Drawing Title : IDI 1100 Rev B – Component Layout
 Alternate 5V Supply Connection

Client : INTELLIGENT DEVICES INC

Drawing Number : 104-00015

Alternate 5V Supply Connection

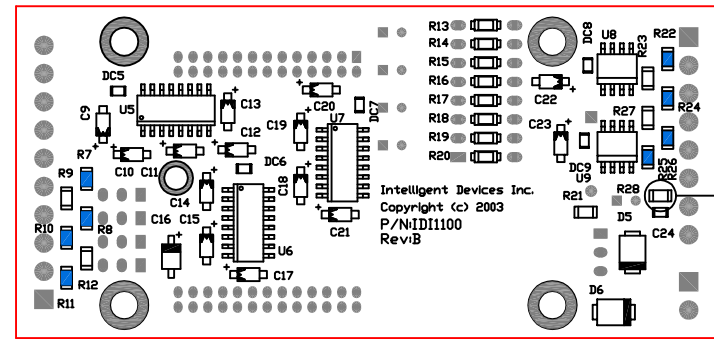
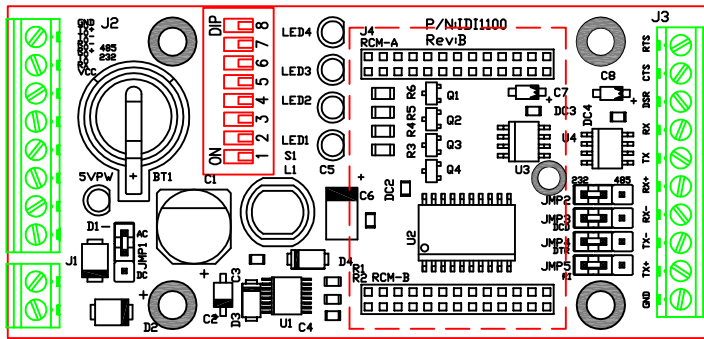
Remove R28 100 ohm 0805 Resistor.
 Replace R28 with 0 ohm 0805 Resistor OR Wire Jumper.
 Connect 5V supply to J2 Pin 8.
 Connect GND to J2 pin 1.
 No connections required to J1.
